**April 26, 2011 TIR Addendum WEBINAR Part I  
FREQUENTLY ASKED QUESTIONS AND ANSWERS  
TECHNICAL INTERCONNECTION REQUIREMENTS**

**Webinar I**

**a. Example of Protection Applications**

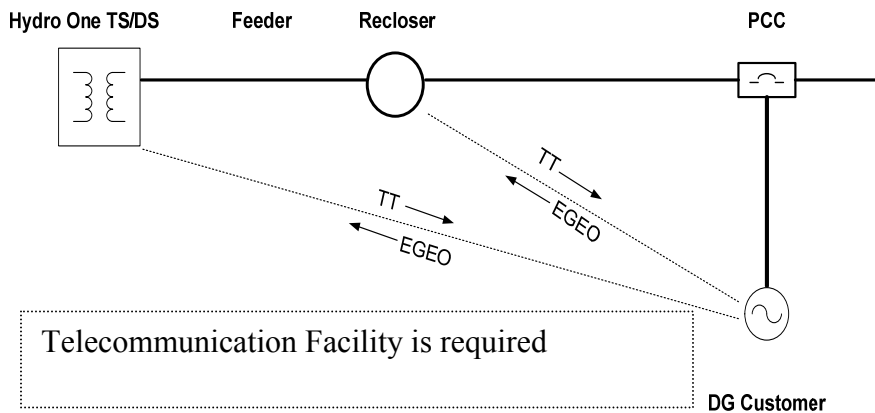
**1. Why has a section been added on Telecommunications Requirements?**

The current version of the TIR only mentioned control and telecommunications requirements, however Telecommunication Facility is also required to transport protection signals, such as Transfer Trip from the Hydro One TS/DS or Recloser to the DG and DG End Open from the DG to Hydro One TS/DS and Recloser. Telecommunication facility is also required for real-time monitoring and control to ensure that critical alarms are received at the Ontario Grid Control Centre and to provide control capability to the operators to intervene efficiently when required.
